VIRGINIA ELECTRIC AND POWER COMPANY
RICHMOND, VIRGINIA 23261

VIRGINIA ELECTRIC AND POWER COMPANY
SURRY POWER STATION UNITS 1 AND 2
PROPOSED TECHNICAL SPECIFICATIONS CHANGE REQUEST FOR
REINSTATEMENT OF PREVIOUS REACTOR COOLANT SYSTEM
PRESSURE/TEMPERATURE LIMITS, LTOPS SETPOINT, AND LTOPS ENABLE
TEMPERATURE BASIS

ATTACHMENT 1

Marked-up Technical Specifications Pages

Figure 3.1-1 : Surry Units 1 and 2 Reactor Coolant System Heatup Limitations (Heatup Rates up to 60°F/hr) Applicable for the first 47.6 EFPY for Unit 1 and 48.1 EFPY for Unit 2 (Including Margins for Instrumentation Errors)

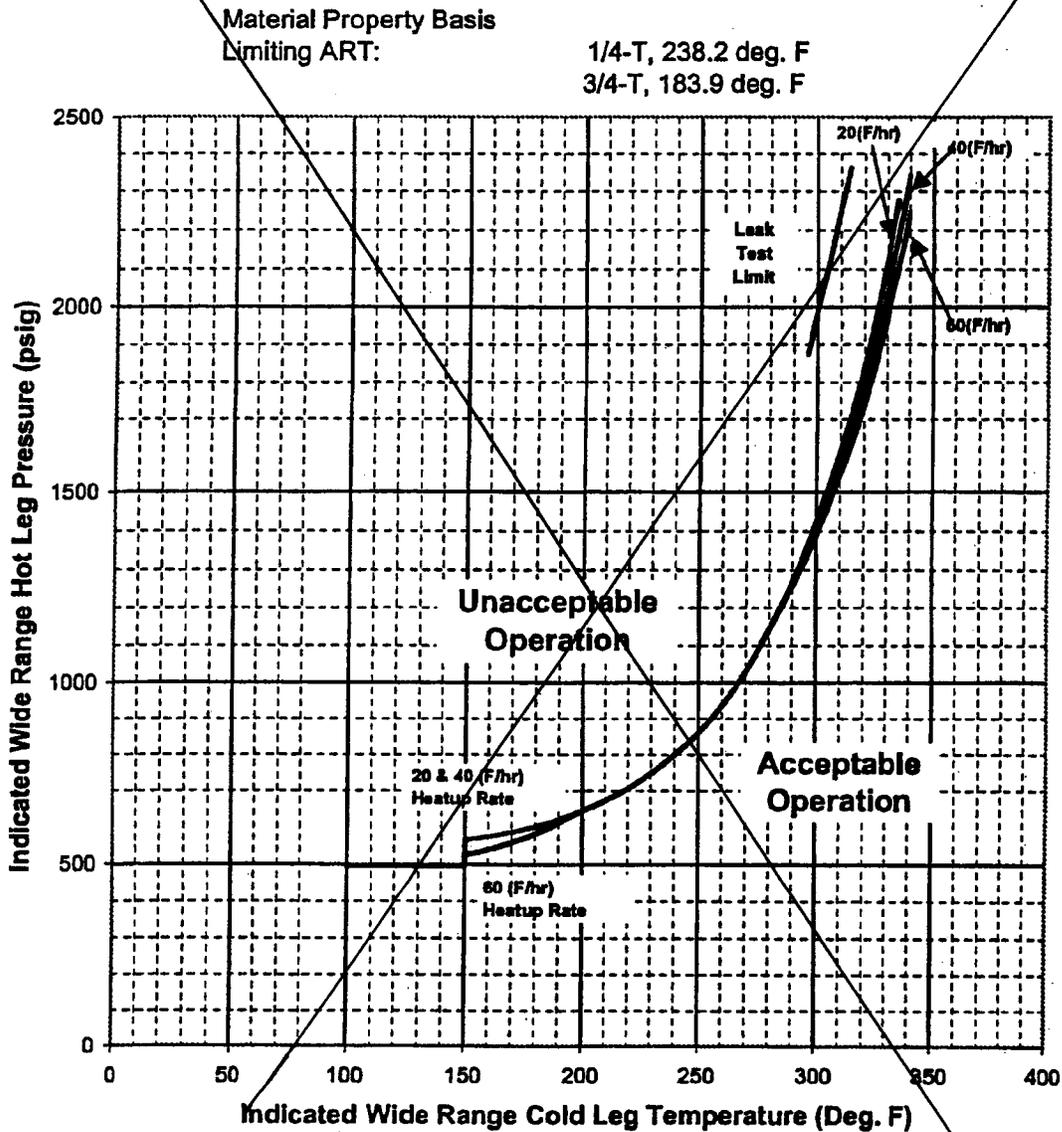
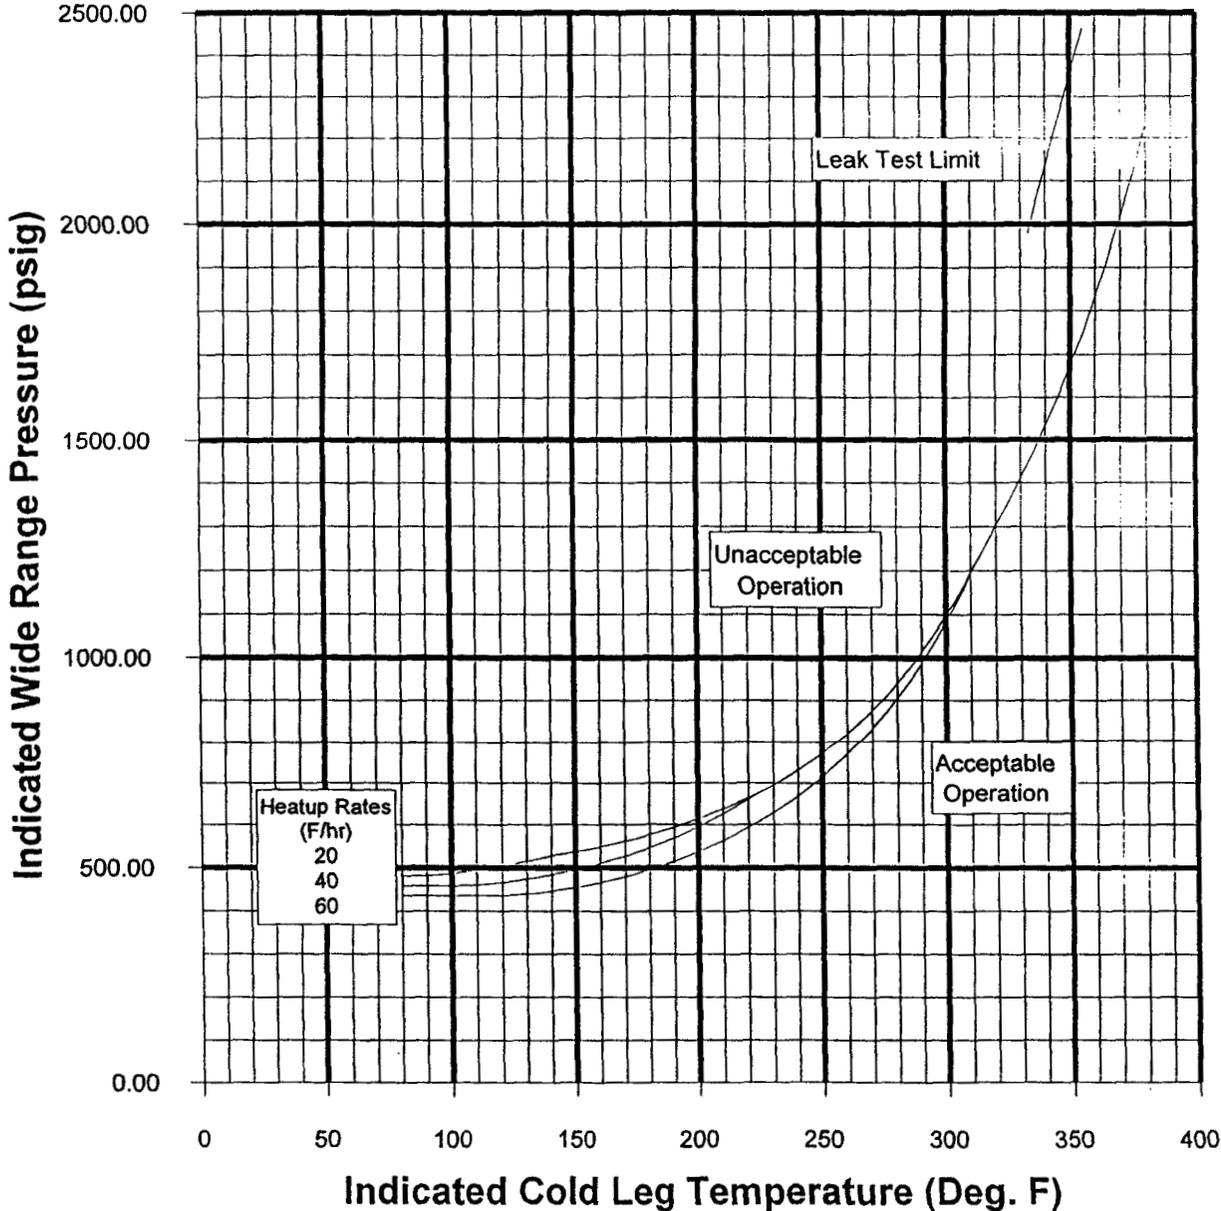
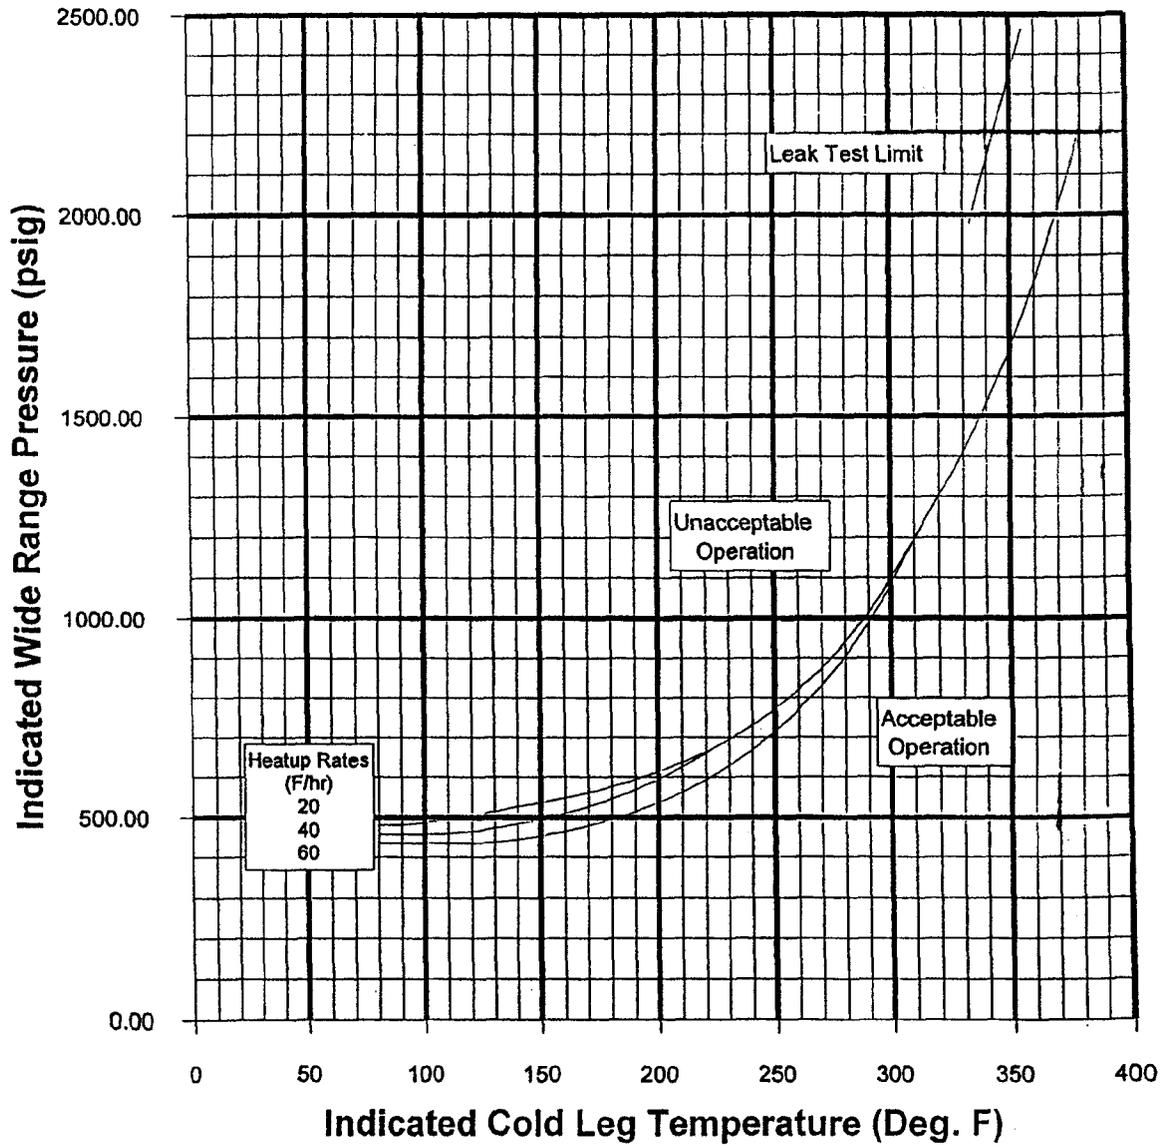
- TS 3.1.B - Replace Figures 3.1-1 and 3.1-2 and the cumulative core burnup limits with the Figures 3.1-1 and 3.1-2, Reactor Coolant System Heatup and Cooldown Limitations previously approved by the NRC in License Amendments 207/207 for Surry Units 1 and 2, respectively (Reference 8.1). The proposed curves will be valid for both Surry Units 1 and 2. Associated TS Basis changes are also being implemented to return to the previous TS Basis text.
- TS 3.1.G.1.c(4) - This specification has been revised to reflect the proposed maximum allowable LTOPS setpoint value of 390 psig as previously approved by the NRC in License Amendments 207/207 for Surry Units 1 and 2, respectively.

Replace with attached Figure 3.1-1

Figure 3.1-1 : Surry Units 1 and 2 Reactor Coolant System Heatup Limitations (Heatup Rates up to 60°F/hr) Applicable for the first 28.8 EFPY for Surry Unit 1 and the first 29.4 EFPY for Surry Unit 2
